**Redegørelse i anledning  
af tre havarier  
med Dash8 Q400**

**Bilag til redegørelsens kap. 6**

SUBJECT: In-Service Incident – Right Main Landing Gear Collapse after Landing

1 TITLE <b>Inspection procedure for retraction actuators p/n 46550-7 or 46550-9 rod end.</b>			2 RD NUMBER <b>8/4-32-059</b>	
			3 SECTION <b>1</b>	4 SHEET <b>1</b>
5 PRIME DESIGN ACTIVITY <b>BOMBARDIER INC., DOWNSVIEW 71867</b>	6 ADDITIONAL LIMITATIONS <b>NONE</b>	7 SERIES <b>DHC-8-400</b>	8 APPLICABILITY <b>Models 400, 401 and 402</b>

**Figure 1: Inspection Areas**

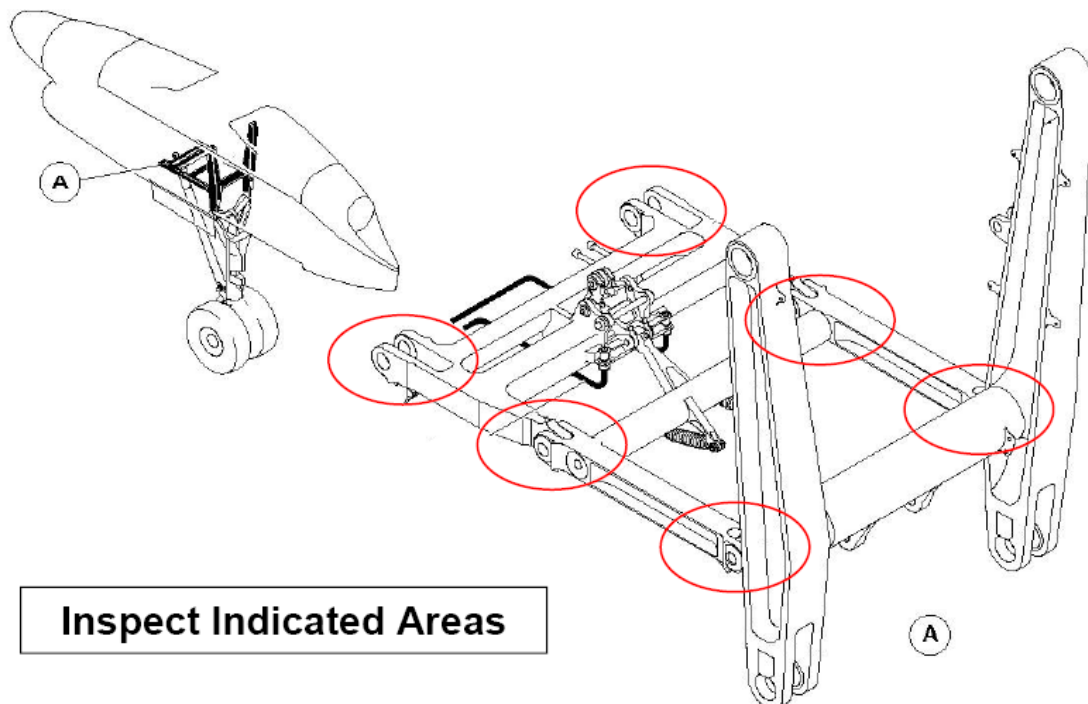
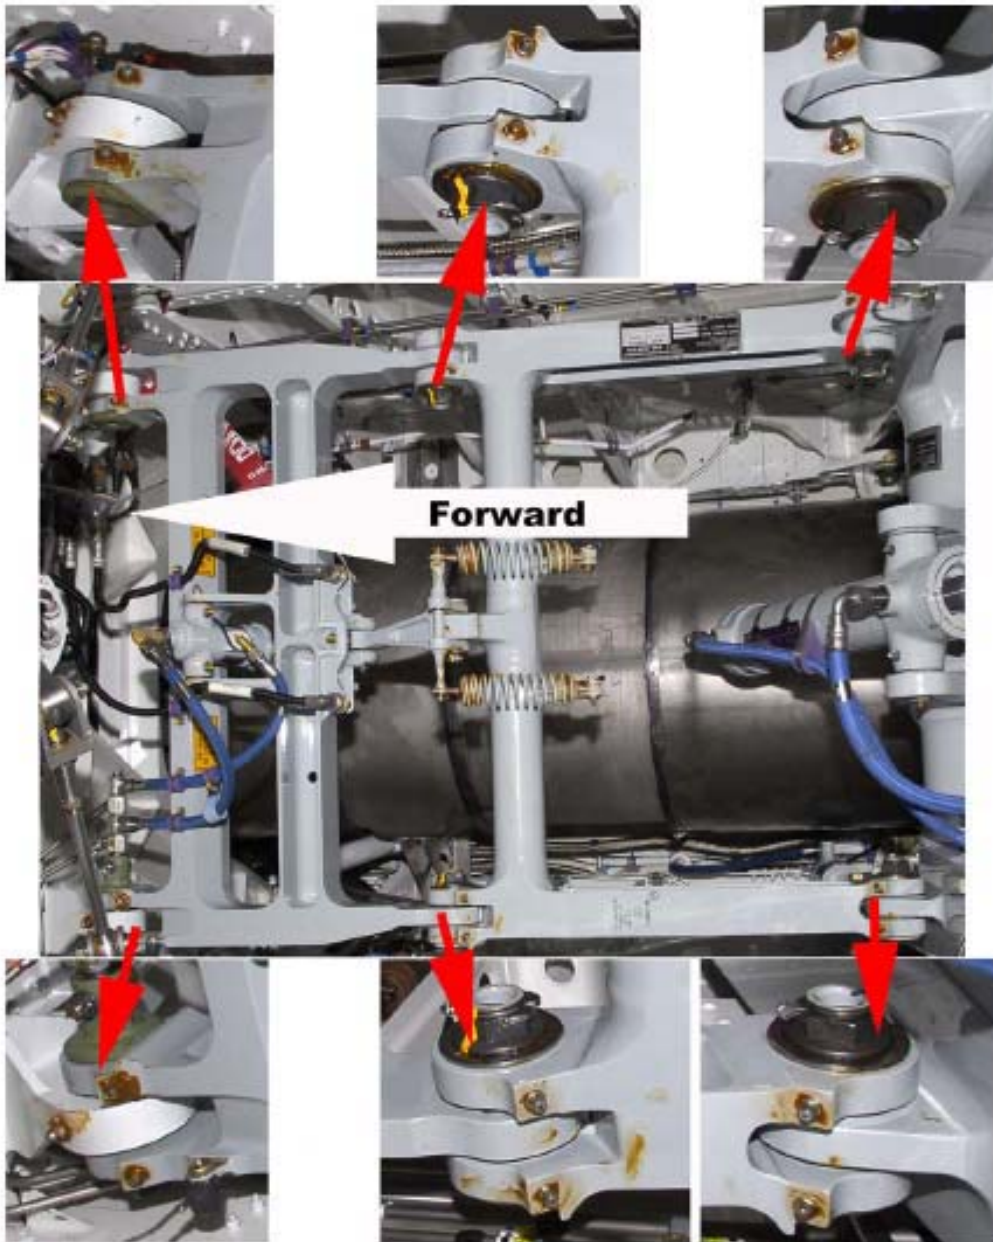
This AOM is being re-issued to clarify compliance time and actions requested.

Operators will be advised as the investigation progresses and further information becomes available.

1 TITLE Inspection procedure for retraction actuators p/n 46550-7 or 46550-9 rod end.		2 RD NUMBER 8/4-32-059	
		3 SECTION 1	4 SHEET 1
6 PRIME DESIGN ACTIVITY BOMBARDIER INC., DOWNSVIEW 71867	6 ADDITIONAL LIMITATIONS NONE	7 SERIES DHC-8-400	8 APPLICABILITY Models 400, 401 and 402

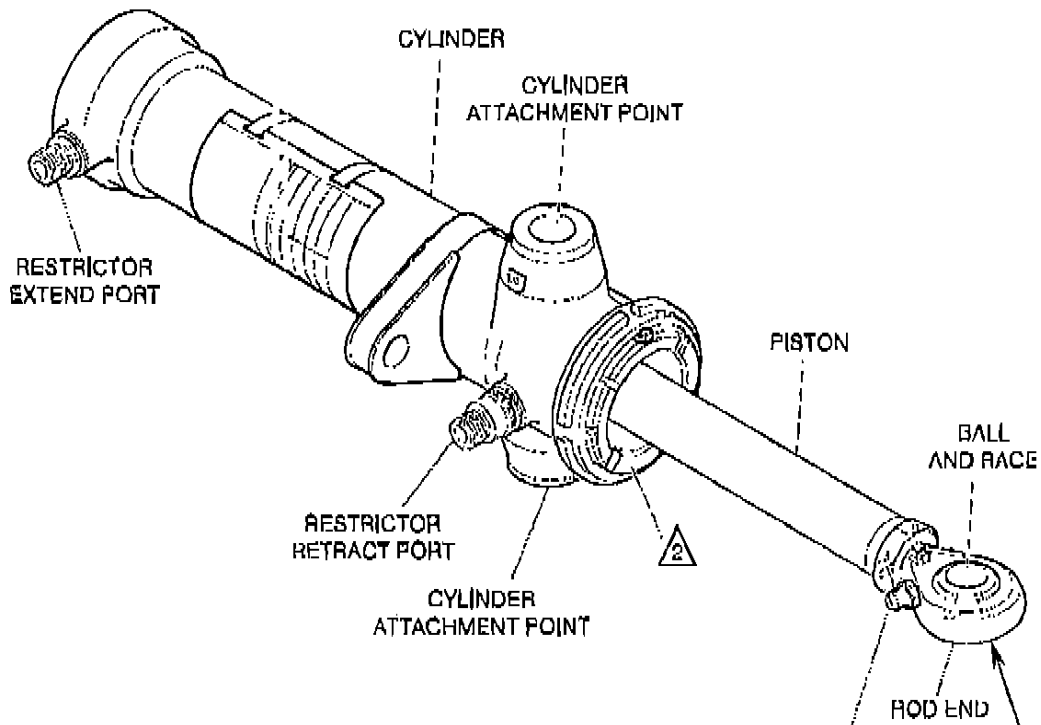
*AT ISS. 2: SCR REF CHANGED TO REV. A, WAS REV. NC*

Remove the rod end of the retraction actuator assembly in accordance with SCR 086-07 rev. ~~REV. A.~~

1 TITLE Inspection procedure for retraction actuators p/n 46550-7 or 46550-9 rod end.			2 RD NUMBER 8/4-32-059	
			3 SECTION 1	4 SHEET 1
6 PRIME DESIGN ACTIVITY BOMBARDIER INC., DOWNSVIEW 71867	6 ADDITIONAL LIMITATIONS NONE	7 SERIES DHC-8-400	8 APPLICABILITY Models 400, 401 and 402

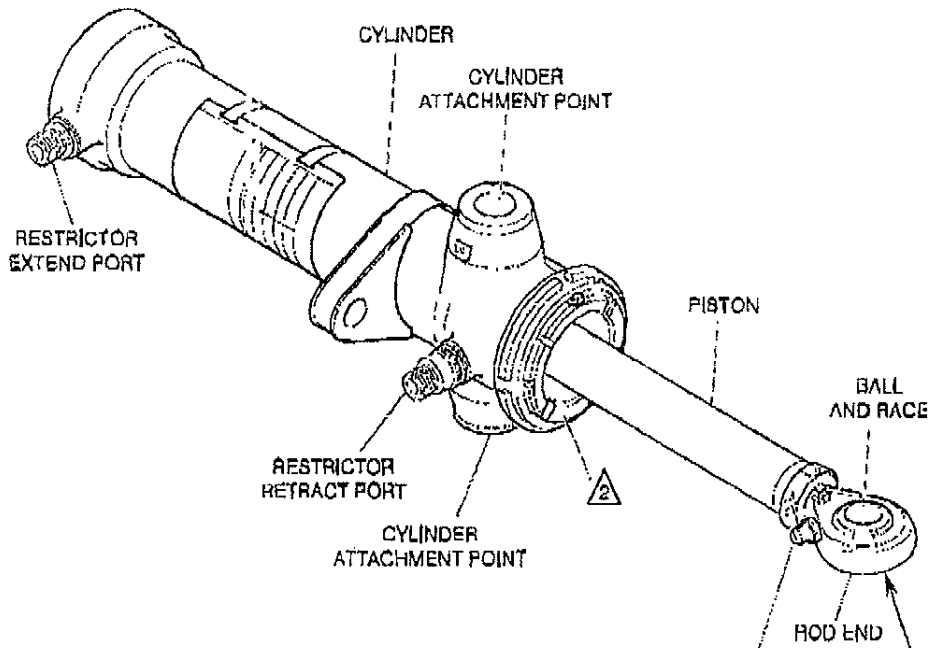
AT ISS. 2: SCR REF CHANGED TO REV. A, WAS REV. NG

Remove the rod end of the retraction actuator assembly in accordance with SCR 086-07 rev. ~~A~~ B

No corrosion or wear damage is allowed, EXCEPT AS NOTED IN SCR 086-07 REV. ~~A~~ B  
 Provided the components are free of any damage re-assemble retraction actuator in accordance with SCR 086-07 rev. ~~A~~ B

**SECTION B**

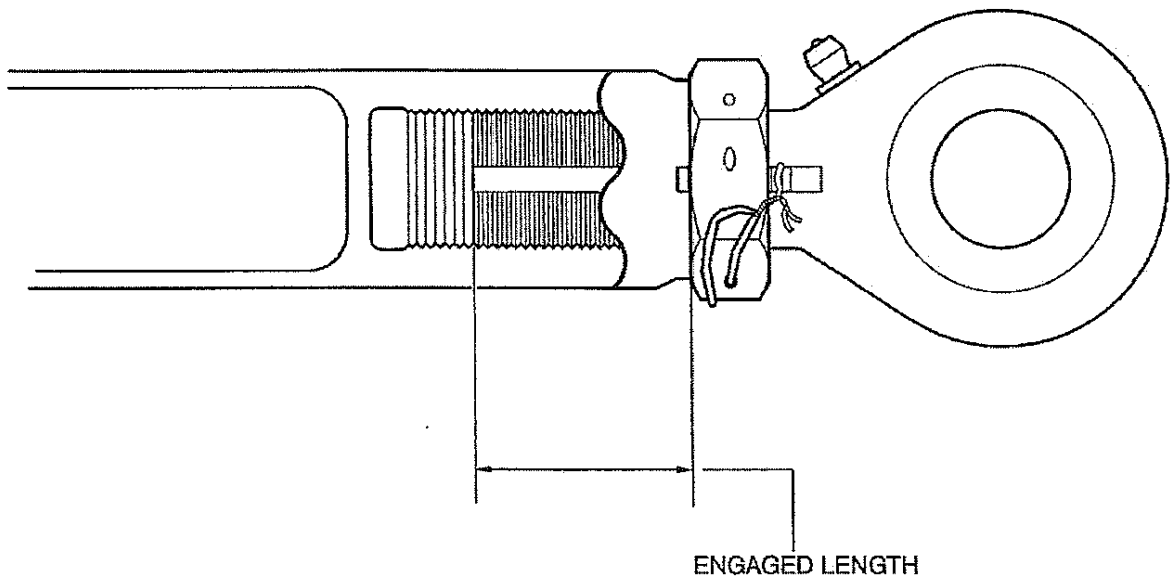
1. MASK AS REQUIRED TO PROTECT ACTUATOR HOUSING, GLAND AREA, AND EXPOSED CHROME OF PISTON FROM F.O.D CONTAMINATION AND DAMAGE DURING THE FOLLOWING REWORK.

2. CHASE PISTON THREADS AND THREAD RELIEF AREA TO REMOVE CORROSION PRODUCTS TO THE GREATEST POSSIBLE EXTENT USING THREAD COMB AND/OR STAINLESS STEEL WIRE BRUSH.

3. INSPECT THE ENTIRE PROFILE OF THREADS OVER THE FULL SPAN OF THREADS (REF. 1.836 DIM, FIGURE 1) AND THE RELIEF GROOVE IN PISTON USING SMALL MIRROR (10X MAGNIFICATION) UNDER ADEQUATE LIGHTING CONDITIONS.

4. **ACCEPTANCE CRITERIA**
  - A) LIGHT SURFACE CORROSION (NO PITTING) OVER THE ENTIRE THREADED LENGTH WITH AT LEAST FIVE CONSECUTIVE FULL UNDAMAGED THREADS WITHIN THE ENGAGED THREAD LENGTH (REF FIGURE 2) IS ACCEPTABLE FOR **1000 FC OR 6 MONTHS** (WHICH EVER OCCURS FIRST) OF CONTINUED SERVICE. RETRACT ACTUATOR TO BE INSPECTED TO ENSURE JAM NUT IS SECURE AND WIRE LOCK IS IN PLACE EVERY **100 FC**.

- B) EVIDENCE OF MODERATE TO SEVERE PITTING CORROSION BEYOND CRITERIA STATED IN A). MUST BE REPAIRED PER SALVAGE DRAWING S2116 OR REPLACED.

**SECTION B**

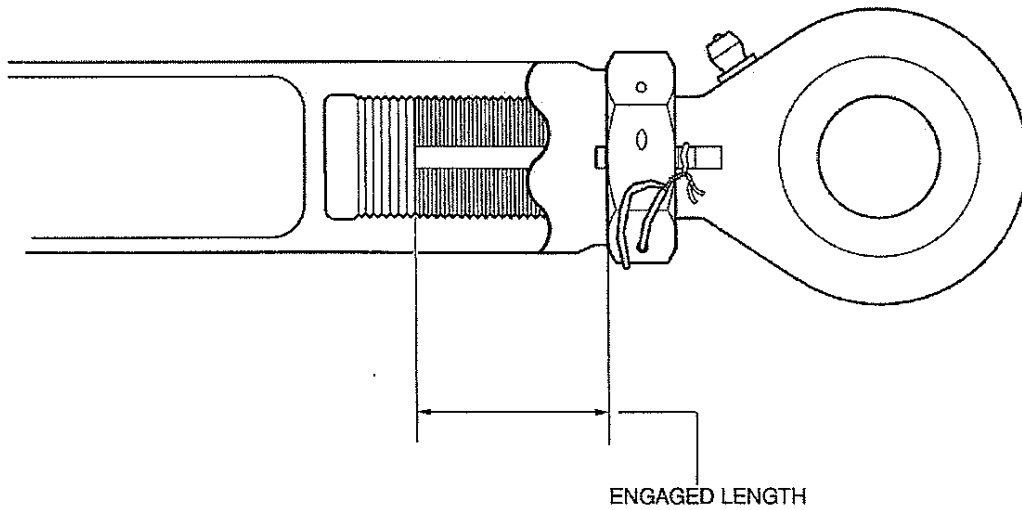
1. MASK AS REQUIRED TO PROTECT ACTUATOR HOUSING, GLAND AREA, AND EXPOSED CHROME OF PISTON FROM F.O.D CONTAMINATION AND DAMAGE DURING THE FOLLOWING REWORK.

2. CHASE PISTON THREADS AND THREAD RELIEF AREA TO REMOVE CORROSION PRODUCTS TO THE GREATEST POSSIBLE EXTENT USING THREAD COMB AND/OR STAINLESS STEEL WIRE BRUSH.

3. INSPECT THE ENTIRE PROFILE OF THREADS OVER THE FULL SPAN OF THREADS (REF. 1.836 DIM, FIGURE 1) AND THE RELIEF GROOVE IN PISTON USING SMALL MIRROR (10X MAGNIFICATION) UNDER ADEQUATE LIGHTING CONDITIONS.

4. **ACCEPTANCE CRITERIA/REWORK OPTIONS**
  - A) LIGHT SURFACE CORROSION (NO PITTING) OVER THE ENTIRE THREADED LENGTH WITH AT LEAST FIVE CONSECUTIVE FULL UNDAMAGED THREADS WITHIN THE ENGAGED THREAD LENGTH (REF FIGURE 2) IS ACCEPTABLE FOR **1000 FC OR 6 MONTHS** (WHICH EVER OCCURS FIRST) OF CONTINUED SERVICE. THE RETRACT ACTUATOR IS TO BE INSPECTED TO ENSURE JAM NUT IS SECURE AND WIRE LOCK IS IN PLACE EVERY **100 FC**
